MEMO

TO: Keith Davis
FROM: Bret Highley *BH*
Date: February 16, 2018
RE: Maryville Gym – Acoustical Issues

Change Order

PROJECT: (Name and address)
Maryville Elem School Addition / Renov.
4504 Highway 44 East
Shepherdsville, Kentucky 40229

PR 14.1

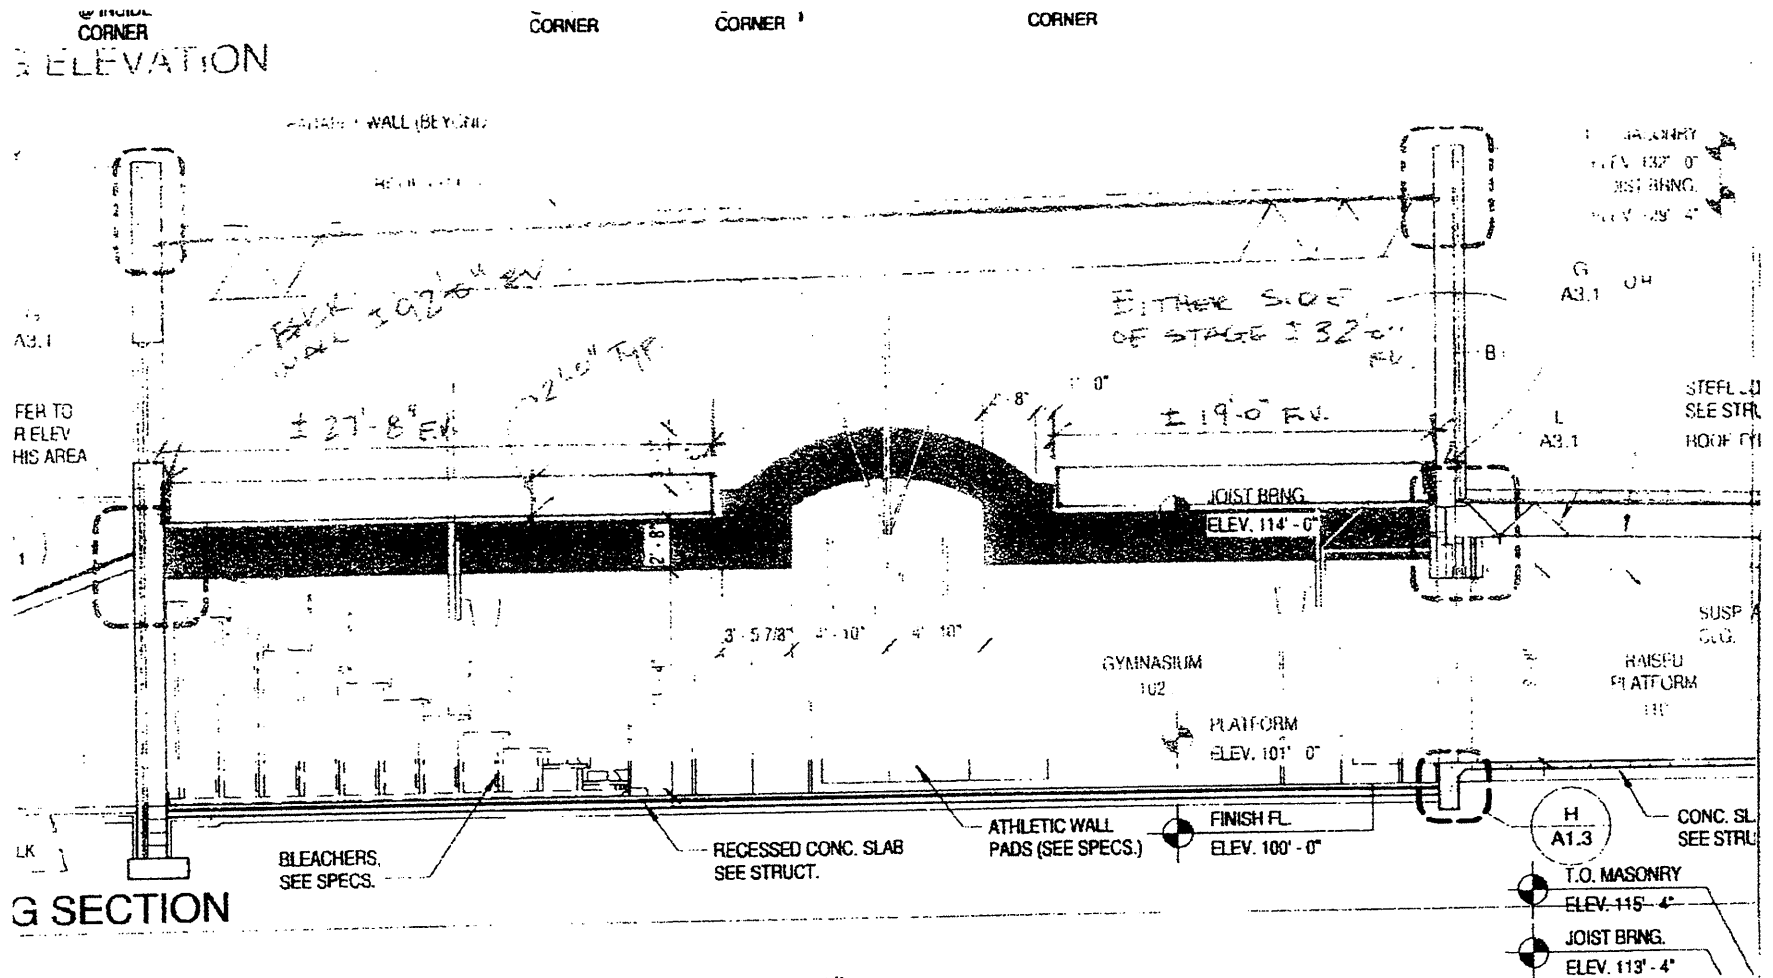
Provide itemized pricing for all labor and material to provide and install Tectum wall panels at all four gymnasium walls per attached sketch. Tectum Wall panels to be Tectum Fabri Tough Wall Panels with NRC of .90. Fabric color selection by owner from manufacturer's full range of fabric colors.
